Planning Permit Application 21H0350
7 Lot Subdivision
At Lot 2 LP91903 Craig Ave. Warracknabeal 3393
Responsible Authority Reference No. TP24-22
SPEAR Reference No. S192927J

**Planning Permit Application Number | TP24-22
Proposal | 7 Lot Subdivision
Address | Lot 2 LP91903 Craig Avenue, Warracknabeal**

Reference No: **TP24-22**
Proposal: **5-lot Subdivision and creation of carriageway easement**
Address: **Craig Avenue Warracknabeal VIC 3393**

Photo 1 - 1974 flooding of Craig Avenue and closed entrance to proposed road to Lots 4 and 5

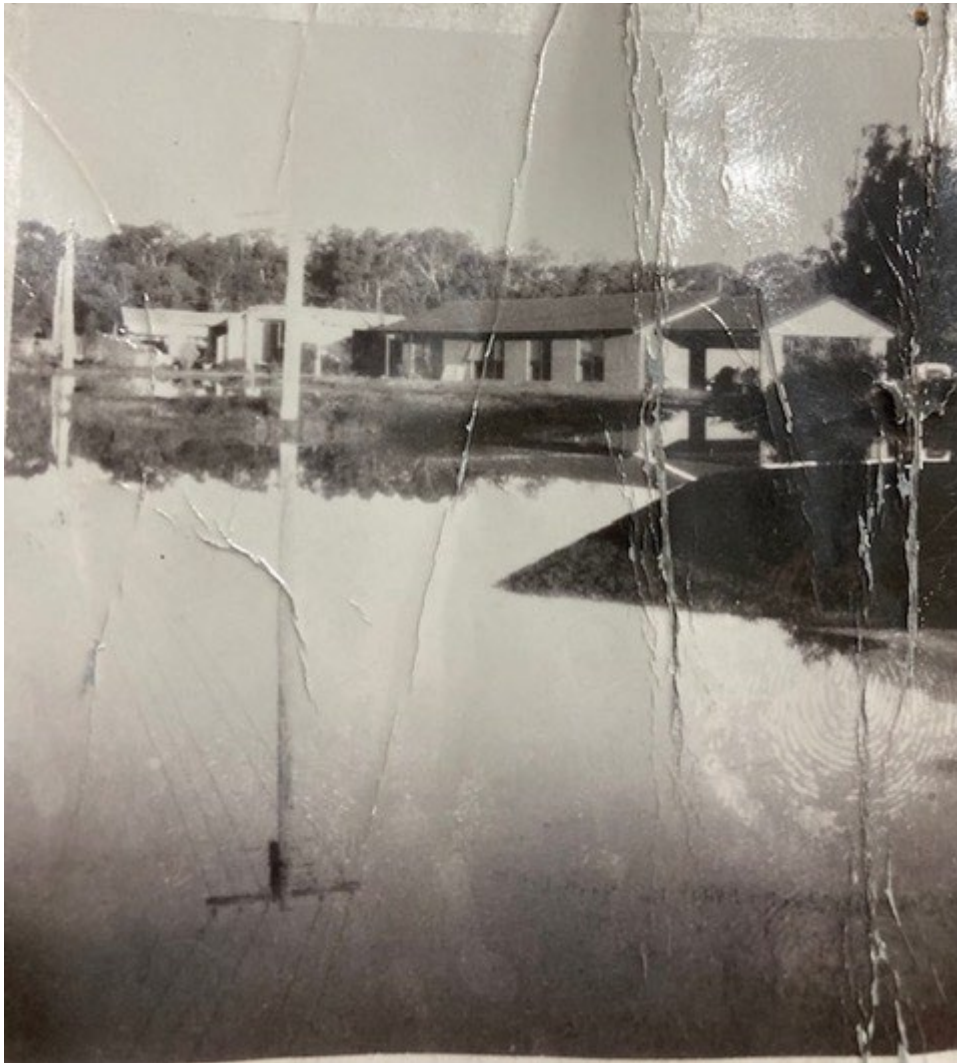
- 1 - 1974 flooding of Craig Avenue and closed entrance to proposed road to Lots 4 and 5
- 2 - 19/01/2011 126 - 128 Craig Ave Fully sand bagged. Flooding through drainage pipes.
- 3 - 19/01/2011 128 to 132 Craig Ave, blocked entrance to Lots 4 & 5. Sandbags stopping town drainage from back flooding.
4. - 19/01/2011 Craig Avenue completely flooded. All areas of W'beal and roads to Warracknabeal shut due to flooding.
- 5 - 18/01/2011 Craig Ave, levee banks being built.
- 6 - 18/01/2011 [redacted] mailbox in flood area, flood water to the north past sand bags.
- 7 - 18/01/2011 Closed entrance to Clarendon Ave road proposed road
- 8 - 18/01/20011 Six kilometres of levee banks being constructed along the Yarriambiack Creek in Warracknabeal in 2 to 3 days..

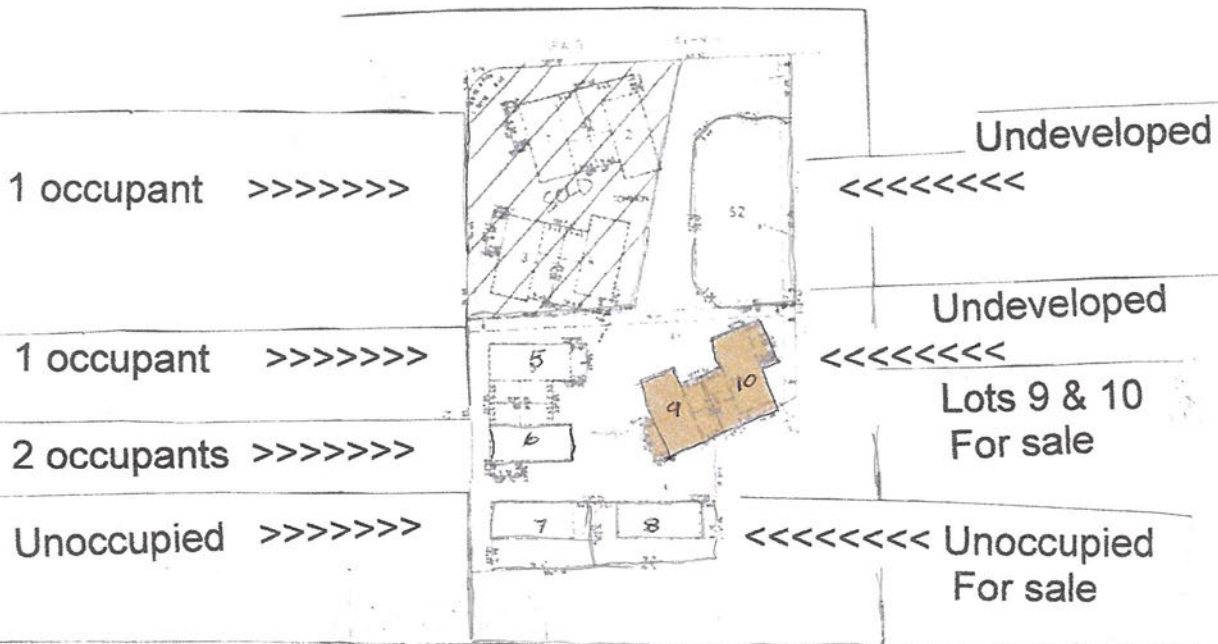
The application for a Planning Permit for this subdivision should not be approved by Yarriambiack Shire Council. The main concern being severe flooding that occurs in the proposed subdivision area.

We also object and question the importation of fill to the lot which we understand represents unpermitted earthworks undertaken during March 2024. It is unclear where this fill was sourced from and whether it is suitably clean. It may also place adjoining Craig Avenue dwellings 124 to 130, at an increased risk of inundation during flood events if the earthworks and related drainage impacts were not considered and approved by Council. If these earthworks did in fact require a planning permit we request Council direct the owner to remove the fill and reinstate the original levels so our property is not placed at increased risk during floods.
